CITIZENS FOR RESPONSIBLE DEVELOPMENT

Response to Valor Development's PUD
Application 19-10
Before the Zoning Commission of the
District of Columbia
October 10, 2019

All Trips Will Flow Through the Alleys

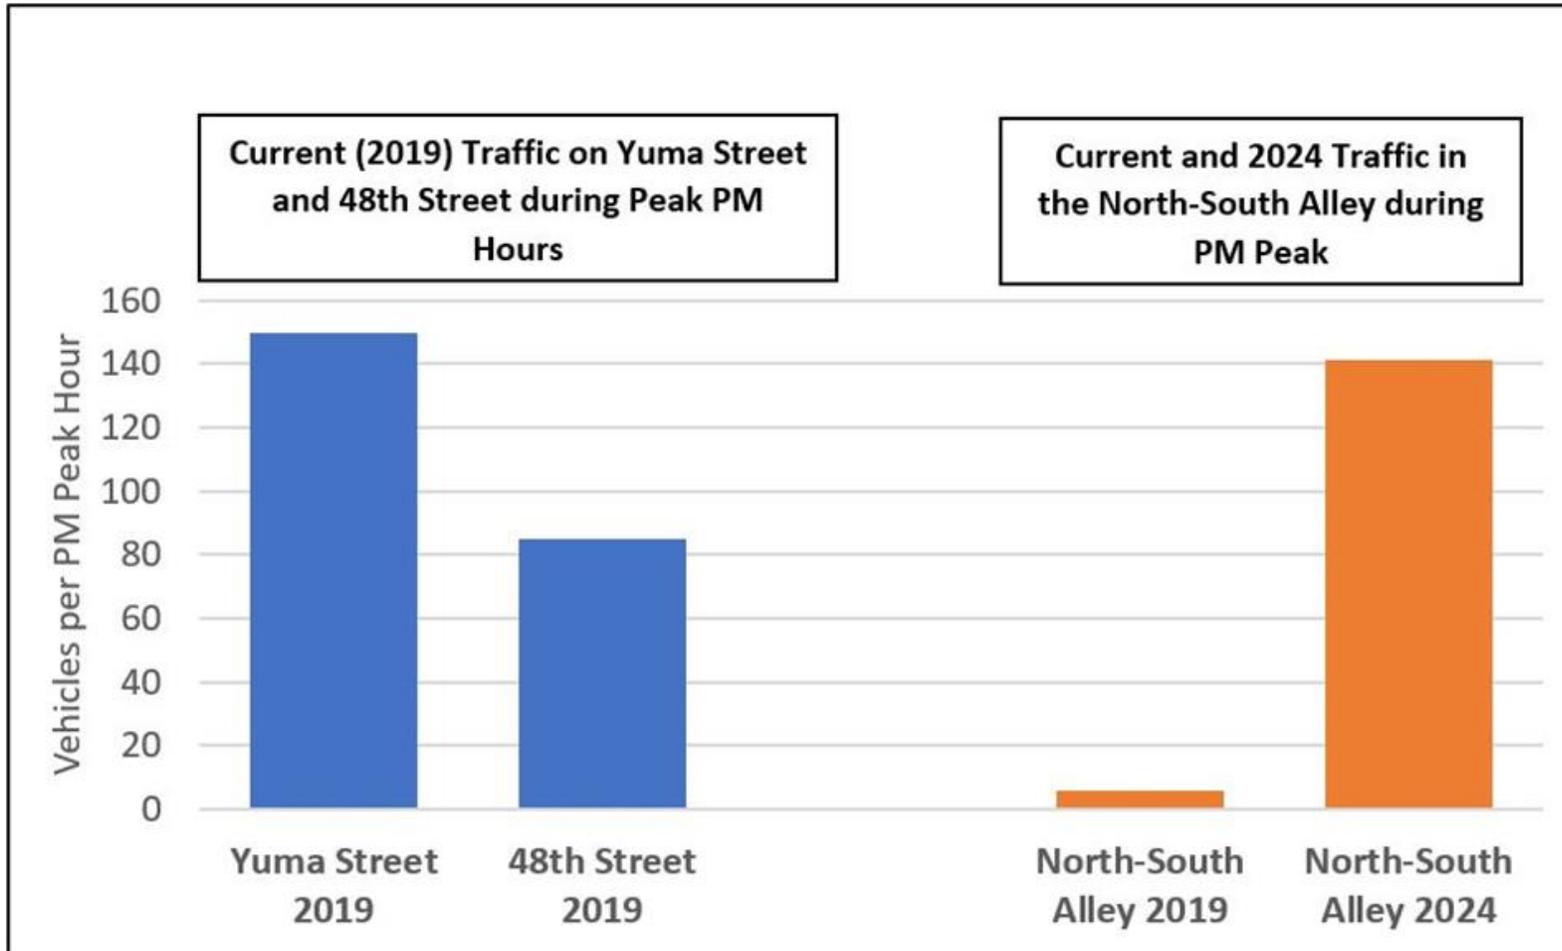
Alley traffic will be comparable to current traffic on 48th and Yuma Streets.

AU Loading Docks are already on the E/W Alley and are used every day.

Figure 14: WB50 Truck Maneuvers - Inbound

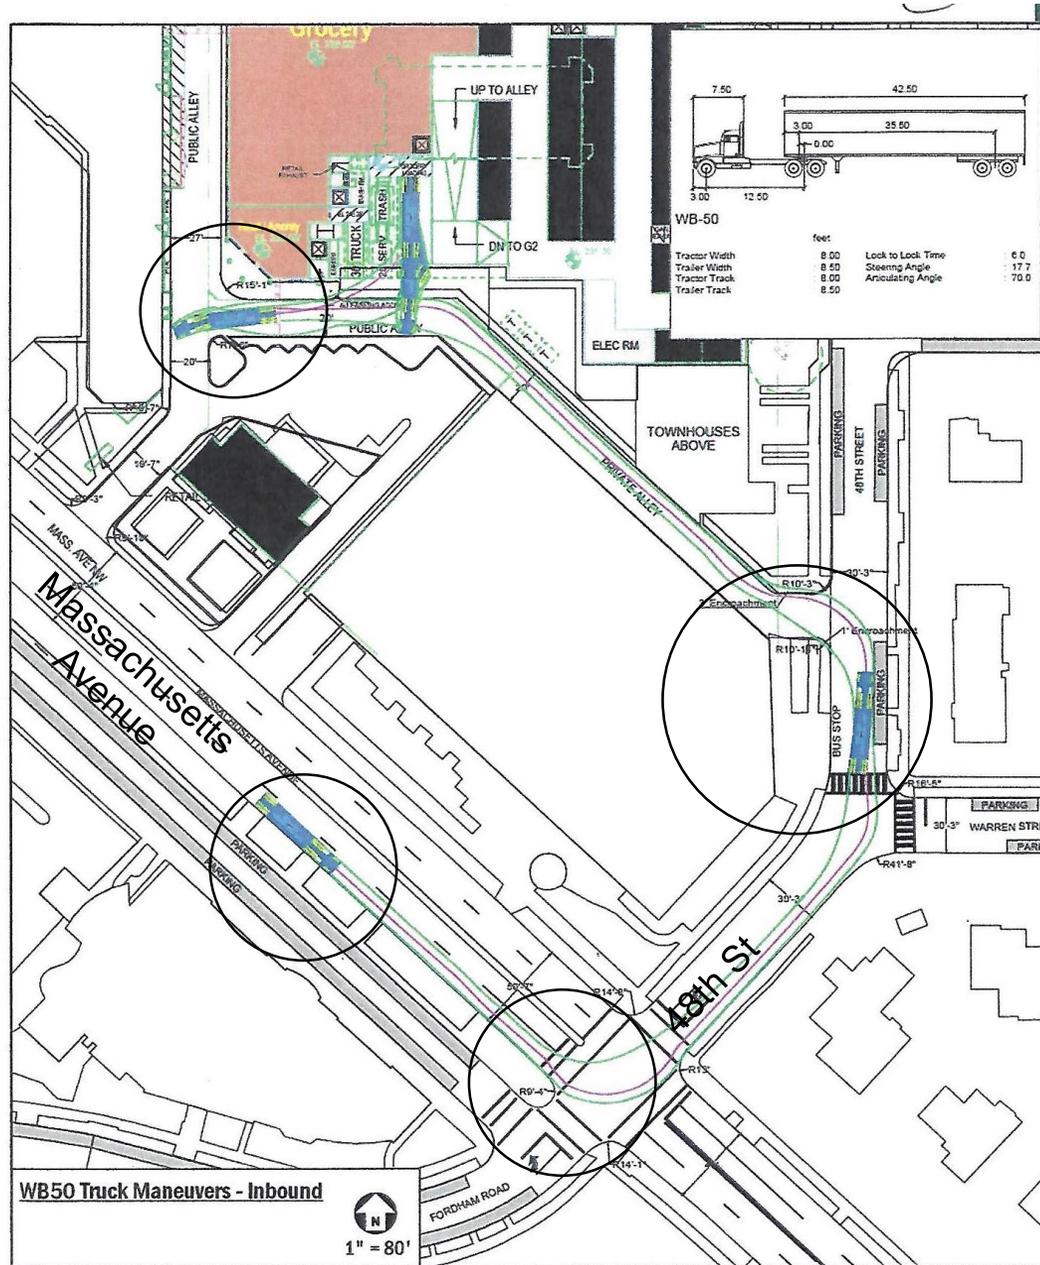
1. Increase in volume of traffic from both cars and trucks;
2. Increase in danger to pedestrians due to increased volume of traffic and inadequate conditions in narrow alleys;
3. Creation of dangerous traffic patterns in the alleys for both cars and trucks;
4. Trucks cannot fit in alleys and will be forced to unload on neighborhood streets.

Proposed design of N/S alley, shifted to the east; Valor building in red; 3-ft wide sidewalk in blue

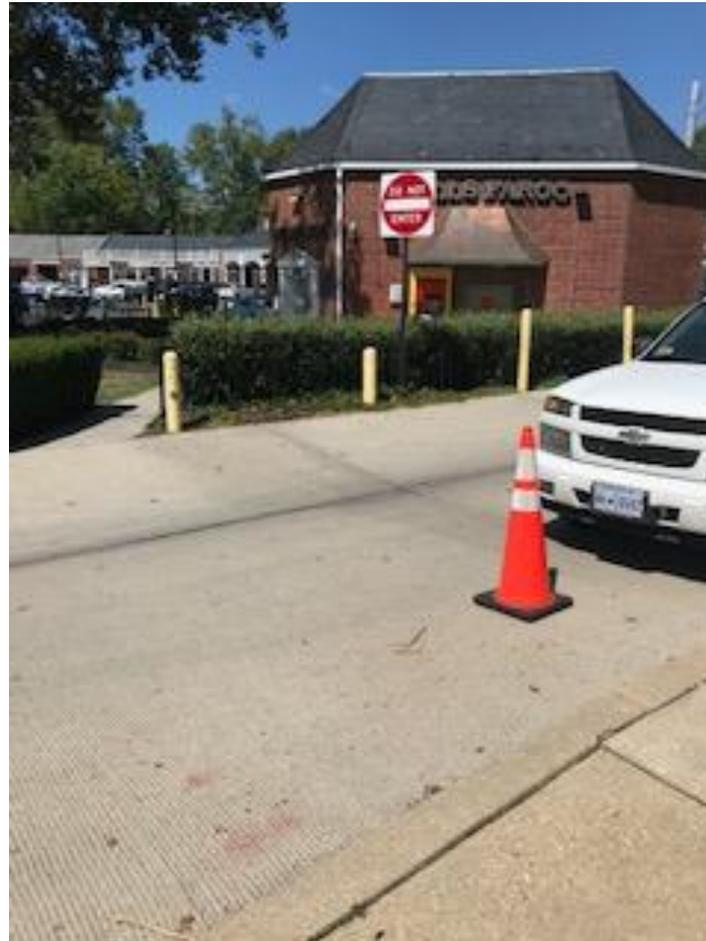
N/S Alley Exit is Currently Only One-way.
